Office Action Summary

10/561,331

BAILEY, MARSHALL GRAHAM

DETAILED ACTION

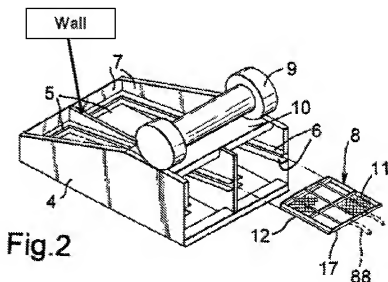
Claims 13, 16 and 17, Wiseman teaches the basket of claim 9 but does not teach the flow distributor including a wall, the basket forming part of a multi basket assembly or the basket including a lateral divider. WO teaches a basket comprising a flow distributor comprising a wall/lateral divider (see below) formed and arranged to define a

plurality of laterally adjacent flow pathways and the basket comprising having a multi-basket assembly comprising a plurality of baskets (5) (fig. 2, below). The claim would have been obvious because all the claimed elements were known in the prior art and one skilled in the art could have combined the elements by known methods with no change in their respective functions and the combination would have yielded predictable results to one of ordinary skill in the art at the time of the invention, KSR International Co. v. Teleflex Inc., 82 USPQ2d 1385 (2007).
